Memorandum

11-SPPE-01

Subject: Please Docket the attached items with this Memorandum attached, for the Xeres Ventures, LLC, Santa Clara SC-1 Data Center, Phase 2, Application for a Small Power Plant Exemption (**11-SPPE-01**).

1. A two-page email exchange – Nora Monette to R. Worl: Temporary Construction Driveway Description, sent to Robert Worl on 1/20/12;
2. A Revised Single-line Primary Distribution Diagram for the SC-1 Data Center;
3. A Typical Uninterrupted Power Supply one-line diagram;
4. Recycled Water Use for Building Cooling (Phase 2) and a Cooling Water Calculation Worksheet.

DUPONT FABROS / SC-1 PLANT
REVISED PRIMARY DISTRIBUTION SINGLE-LINE
 JJ GUENTERT / POWER DISTRIBUTION SYSTEMS
 REV #06 - JULY 21-2011

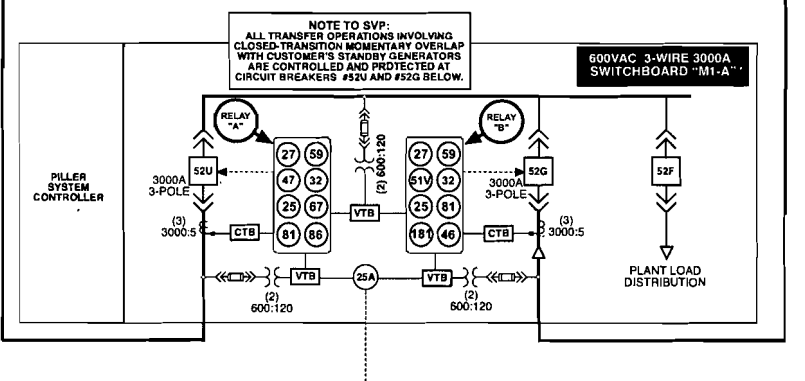
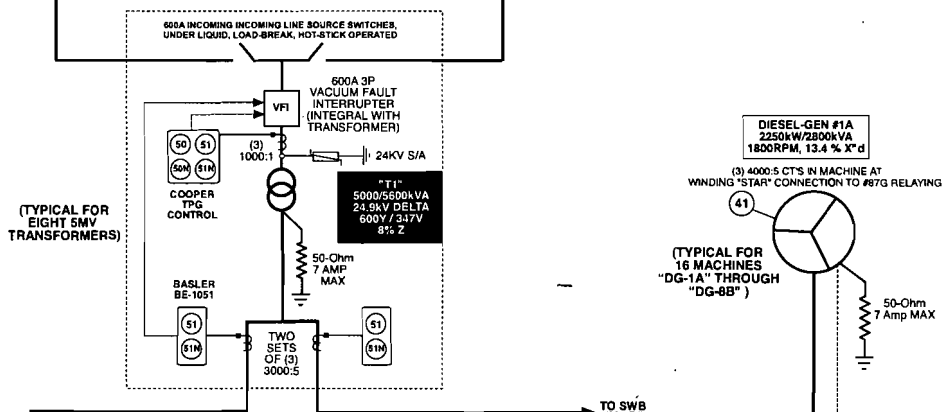
AGREEMENT REACHED DURING JULY 14 MEETING THAT 25KV BUS LEVEL BELOW POWER TRANSFORMERS BECOMES NEW "POINT OF COMMON COUPLING".

ALL PROTECTIVE FUNCTIONS AT 600V LEVEL REMAIN IN PLACE, AS PREVIOUSLY DISCUSSED, EXCEPT THAT REVERSE POWER SETTINGS IN ALL RELAYS "A" CHANGE TO 400KW WITH 1.5 SEC DELAY.

NEW PROTECTIVE FUNCTIONS ARE ADDED AT ALL RELAYS "E" TO COMPLY WITH SVP REQUIREMENTS INCLUDING BACKUP REVERSE POWER TRIP SET AT 500KW, WITH FIXED DELAY OF 2.0 SECONDS.

SVP-REQUESTED #51V FUNCTION HAS BEEN ADDED, DIRECTLY AT THE 600V GENERATOR BREAKER #52G (RELAY "B" BELOW, RIGHT).

REVERSE POWER SETTING AT 600V UTILITY MAIN BREAKER #52-J (RELAY "A" BELOW) REVISED TO 400KW AT 1.5 SEC FIXED DELAY.
